**AERONAUTICAL CHARTING MEETING
Instrument Procedures Group
Meeting 19-02 – October 2019**

RECOMMENDATION DOCUMENT

FAA Control #19-02-346

Subject: Deceleration Segment on STARs Supporting Compliance with 14 CFR 91.117(c)

Fig 1 – EMOZH Three (RNAV) STAR – KOAK

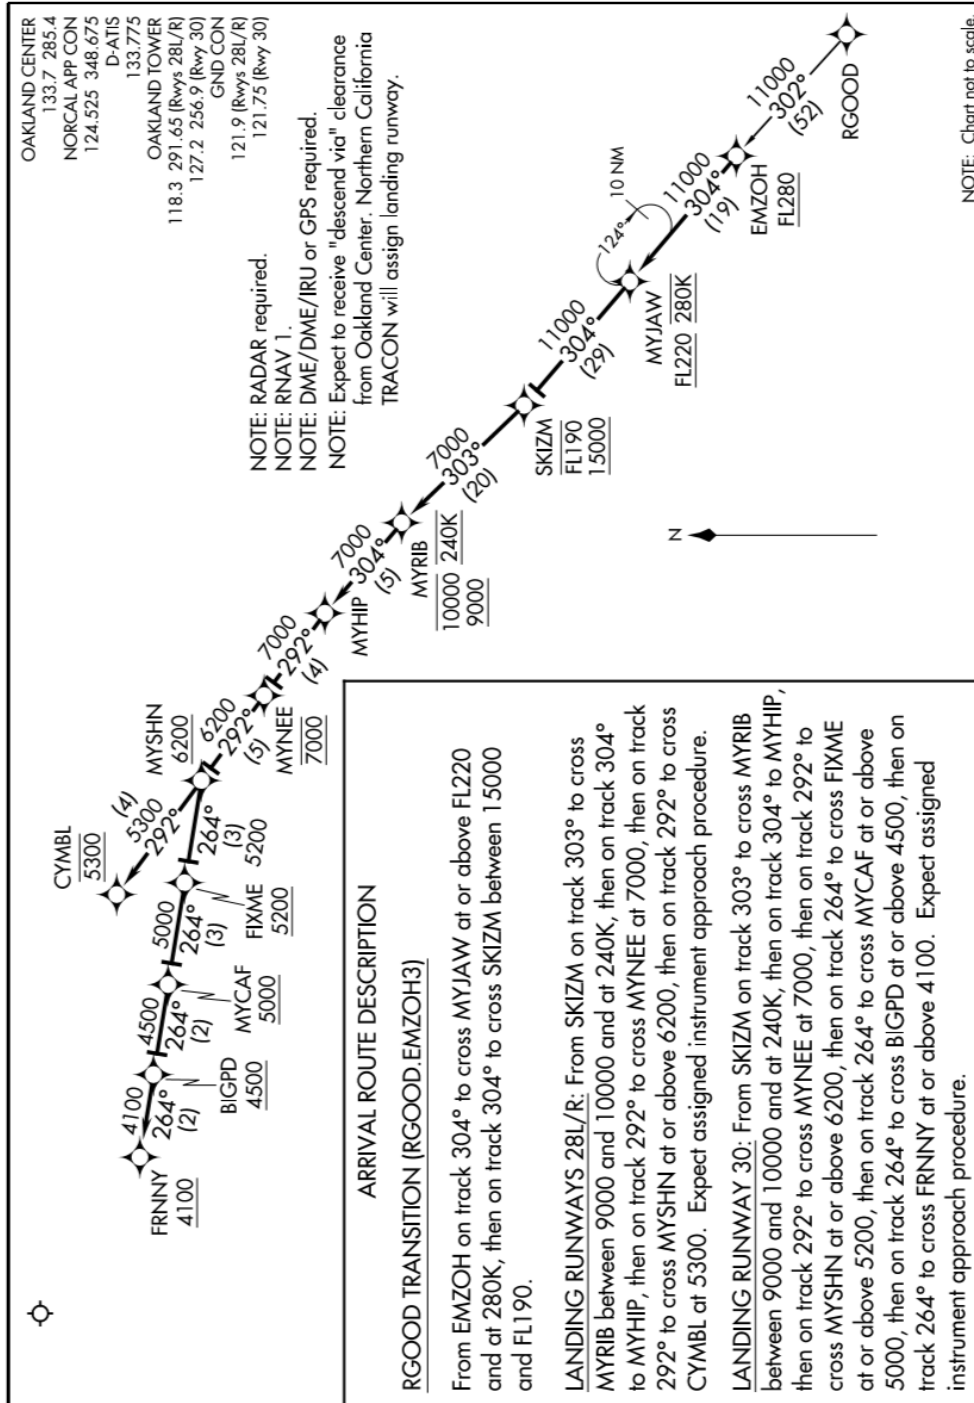
For example, the published altitude restrictions on EMOZH Three (RNAV) STAR for Oakland CA (KOAK) – Figure 1 -- are below the floor of the San Francisco (SFO) Class B airspace starting MYNEE (at 7000') and it remains below the SFO Class B airspace until BIGPD (at or above 4500') – Figure 2. The distance between MYRIB and MYNEE is 9.4 NM. Using the “at or above 9000'” restriction at MYRIB, the descent gradient to the “at 7000'” restriction is 212 ft/NM. However, descending on this path would result in the aircraft going below the SFO Class B's 8000' floor approximately 1.8 NM prior to MYNEE.

Most business airplanes descend on a default path (e.g., 3.0 degrees/ 318 ft/NM). Descending on this default path to the “at 7000'” restriction at MYNEE results in aircraft crossing MYRIB at 9,989 feet MSL, which is in compliance with the “at or below 10,000'” restriction published at this fix. This descent path leaves little opportunity for the crew to reduce speed from the 240 knot restriction at MYRIB to 200 knots below 8000 by 1.8 NM prior to MYNEE (floor of the SFO Class B). NBAA has received reports by member flight crews of the difficulty in reducing speed to

comply with §91.117(c) while descending to meet the published altitude restriction on this STAR.

The guidance in TERPS paragraph 2-2-10 provides some clue as to what descent gradient might be needed. MYRIB has an “at or above 9000’” restriction and MYNEE has an “at 7000’” restriction. MYRIB also has a published speed of 240 knots. Applying formula 2-2-2 in paragraph 2-2-10:

The deceleration distance (DecelD) required to cross MYNEE at 200 knots is equal to $(9000 - 7000 / 250) + 4$ or 12 NM. This equates to a 166.7 ft/NM descent gradient. Compare this to the lowest descent path (212 ft/NM) that complies with the published altitude restrictions at MYRIB and MYNEE. However, the deceleration to 200 knots must be completed 1.8 NM prior to MYNEE if the aircraft is below 8000’ at this position. If the 166.7 ft/NM descent gradient is extended backwards from MYNEE, the aircraft would cross the boundary of the SFO Class B airspace (at 7300’ MSL where its speed would need to be at or below 200 knots).

NBAA recommends that AFS 420 publish guidance in paragraph 2-2-10 for a deceleration segment supporting a speed reduction to 200 knots in accordance with 14 CFR §91.117 (c) when the altitude restrictions on a STAR place the aircraft below the floor of the overlying Class B airspace.
